UNITED STATES PATENT AND TRADEMARK OFFICE

APPLICATION NO.	FILING DATE	FIRST NAMED INVENTOR	ATTORNEY DOCKET NO.	CONFIRMATION NO.
10/626,756	07/24/2003	Kevin Traynor	032674-200	1739

Office Action Summary	Application No.	Applicant(s)	
	10/626,756	TRAYNOR ET AL.	
	Examiner	Art Unit	
	Khanh Dang	2111

DETAILED ACTION

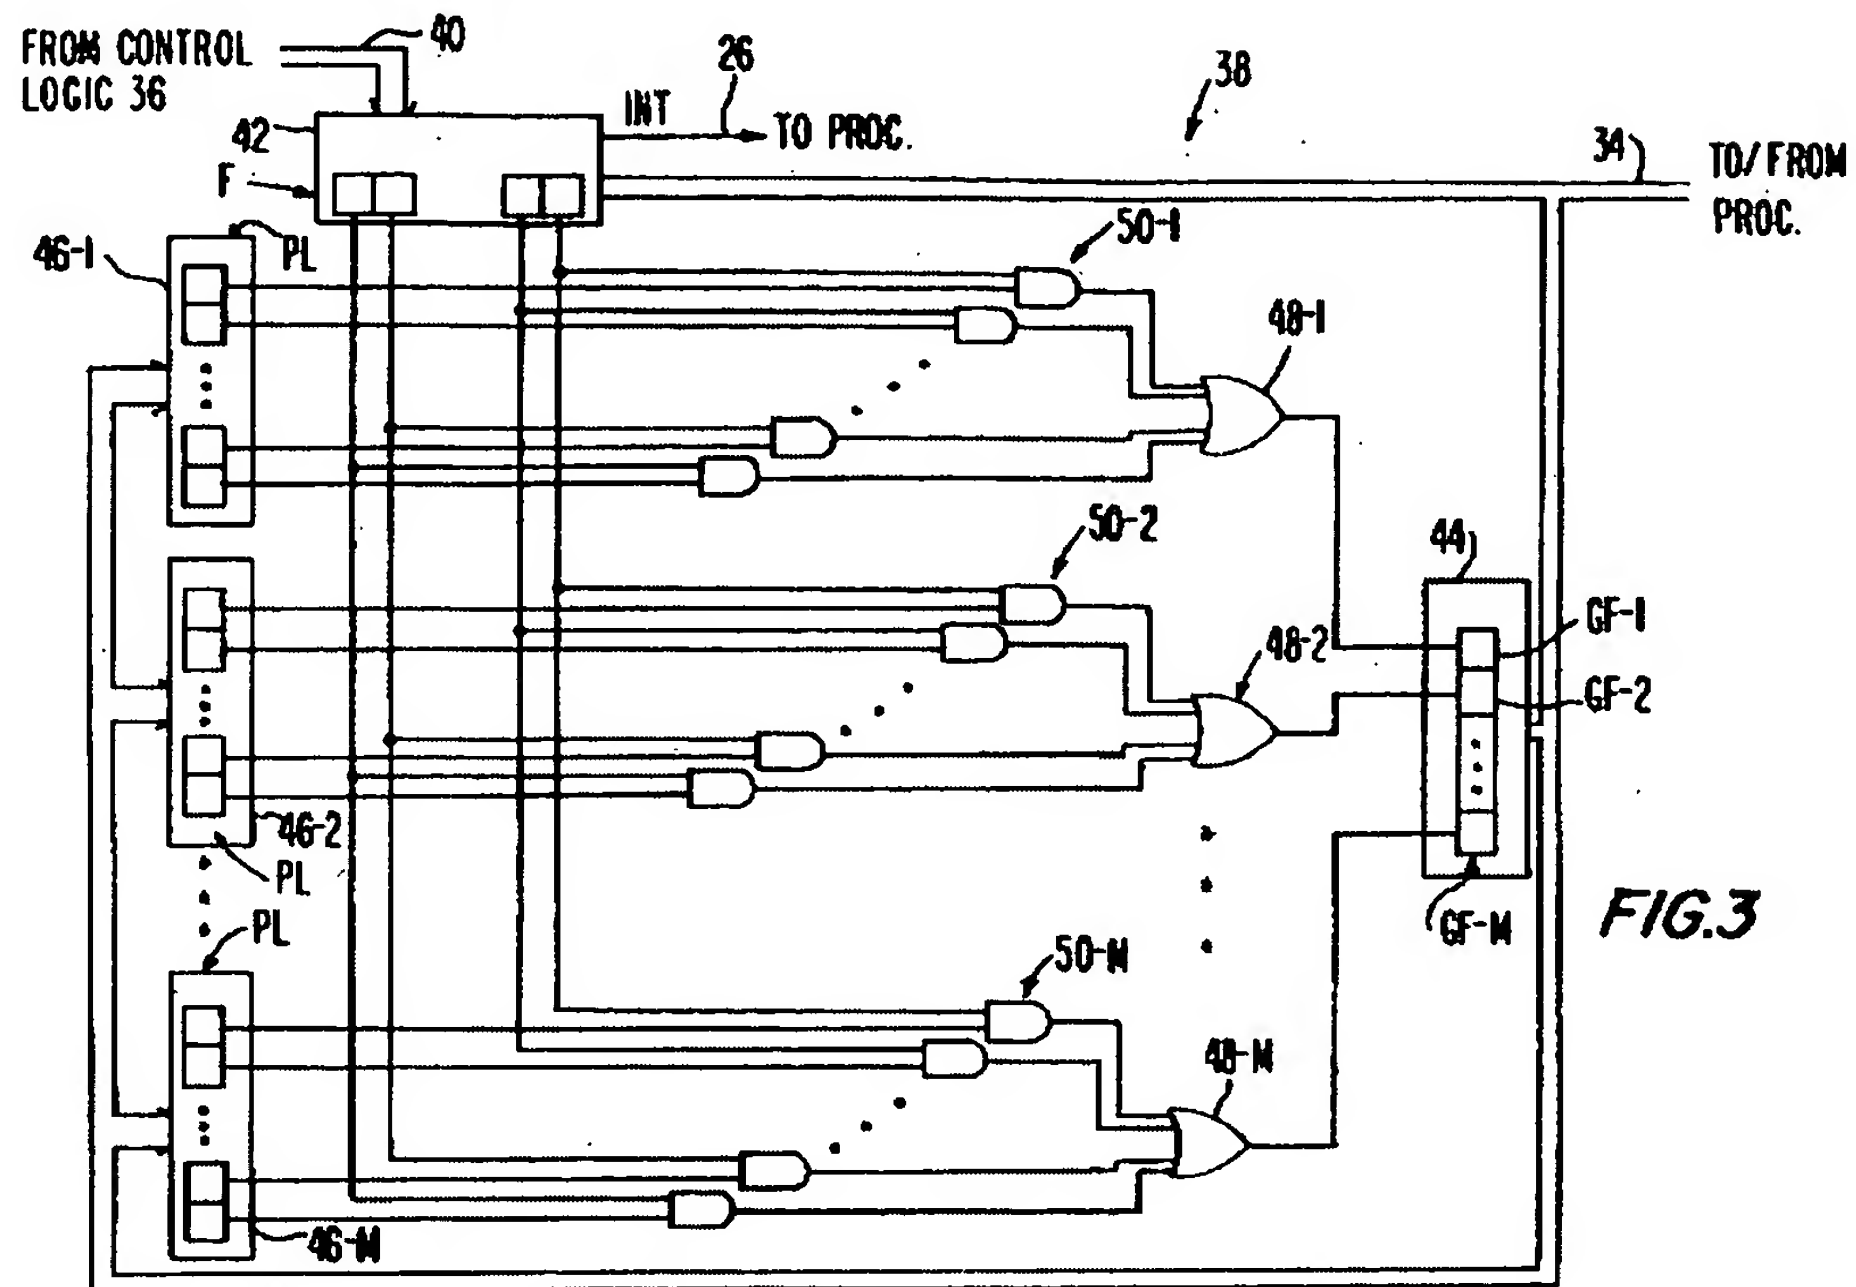
Wach discloses an interrupt architecture employing interrupt sharing, which is best illustrated in the following figure:

At the outset, in order to have a clear understanding of the following discussion, it is important to note that the interrupt requests can be generated from register 44 instead of register 42 (see column 11, lines 10-15). In addition, the term “group” used in Wash includes group that has only one interrupt resource (see column 11, lines 47-49).

As shown above and specifically described in column 4, line 63 to column 6, line 43; column 10, line 55 to column 11, line 48, the number of storage locations F in register 42 is equal to the number of interrupt sources, any one of which may cause the

transmission of the interrupt signal to processor 14. Also, the locations F correspond one-to-one to the interrupt sources. The plurality of interrupt resources are routed or mapped to a plurality of interrupt inputs represented by a plurality of locations GF; wherein the interrupt request signal generated when any one or more of the locations GF are set. Further, in Wash, a masking bit is used to enable or disable interrupt requests from each of a plurality of interrupt sources to one or more of the plurality of interrupt inputs. Specifically, when it is desired to mask a given one of the interrupt sources, processor 14 sends programming signals to the association registers 46 such that the value "0" is stored in the respective location PL corresponding to the interrupt source to be masked.

FIG. 3

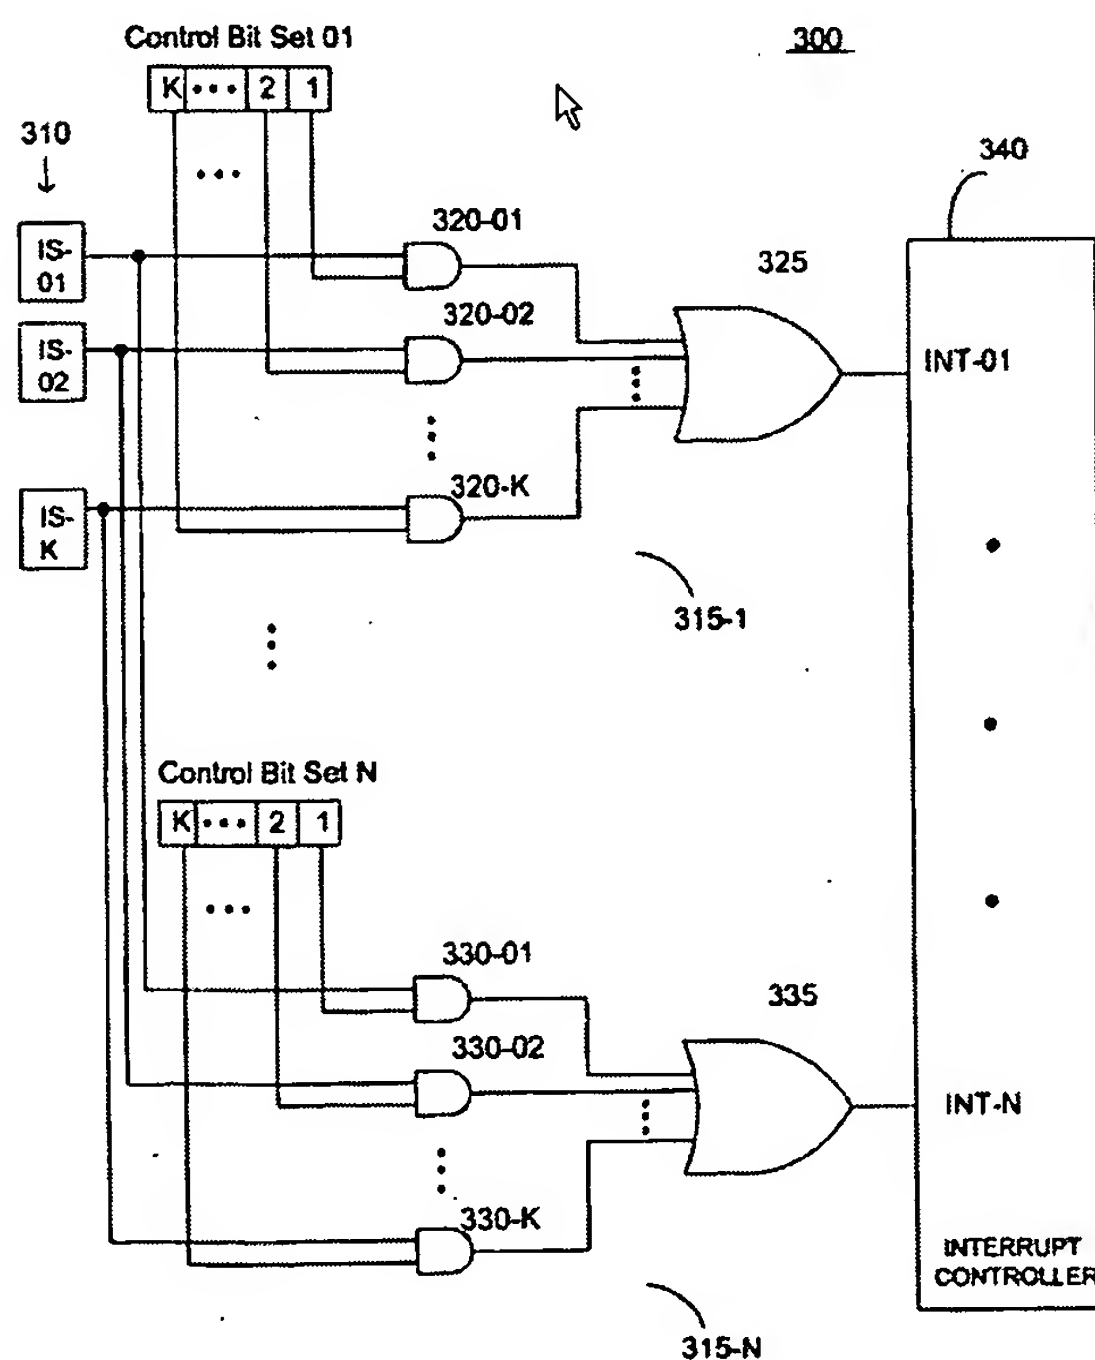
Contrary to Applicants' argument, it is clear that a plurality of location GF of register 44 is readable as a plurality of interrupt inputs. As disclosed in [0012], page 4 of Applicants' originally filed specification and as shown in Fig. 3, the interrupt inputs are defined as follows:

[0012] In yet another aspect of the invention, a system is disclosed for sharing a plurality of interrupt inputs associated with a processor among a plurality of interrupt sources. The system comprises, for each interrupt input, a plurality of logical ANDs, each corresponding to an interrupt source, the corresponding interrupt source providing an interrupt request signal to the corresponding logical AND to interrupt the processor. A plurality of control bits each correspond to an interrupt source and each respectively provide a control bit value to the corresponding logical AND, wherein, based on the control bit value, a corresponding interrupt request signal is provided at an output of the corresponding logical AND. A logical OR is arranged to indicate, to the interrupt input, the presence of a corresponding interrupt request signal from at least one output of the plurality of logical ANDs.

Identically disclosed and shown in **Fig. 3 of Wach:**

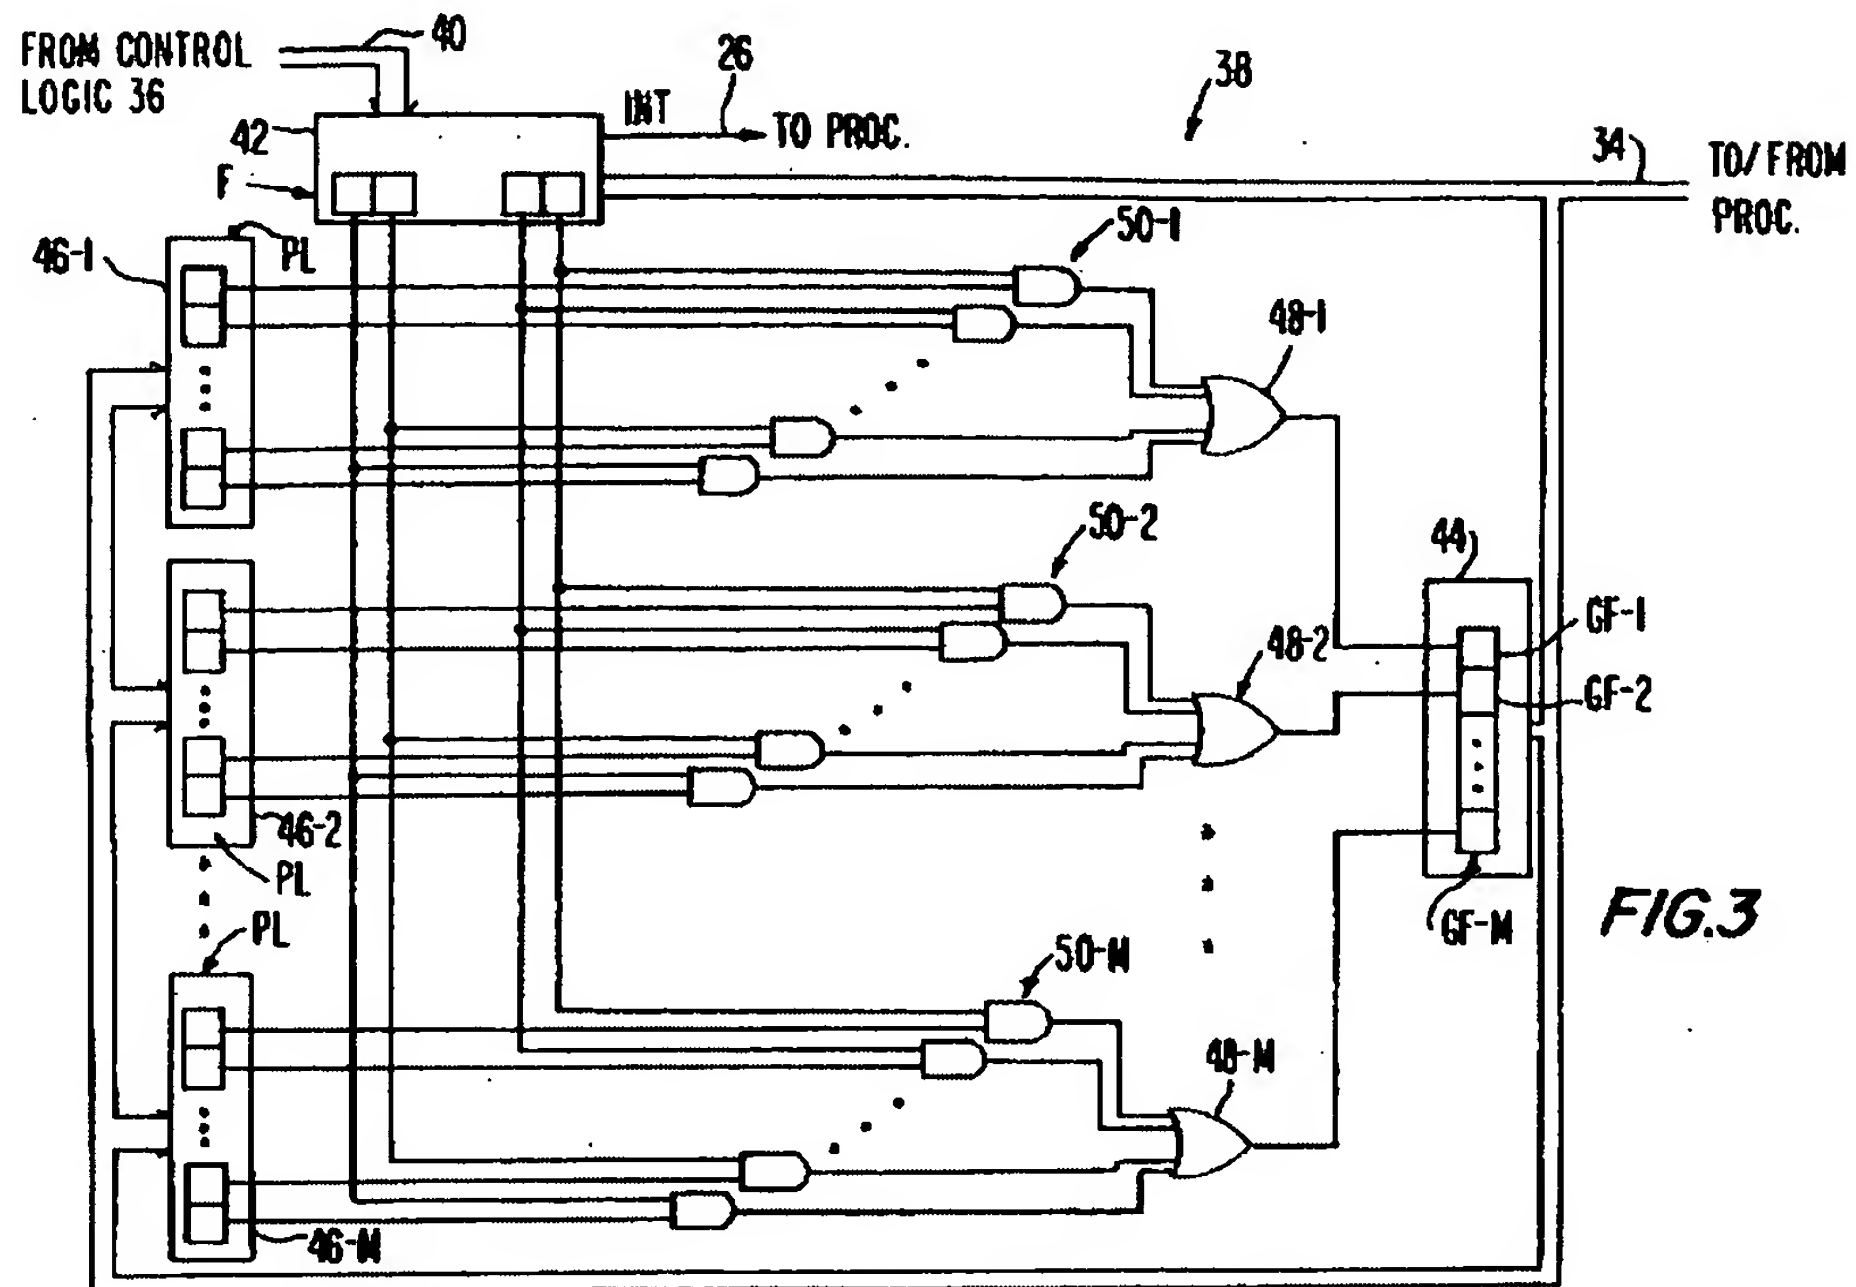
It is clear from at least Fig. 3 of Wach, a logical OR is arranged to indicate, to the location GF or interrupt input, the presence of a corresponding interrupt request signal from at least one output of a plurality of logical AND gates.
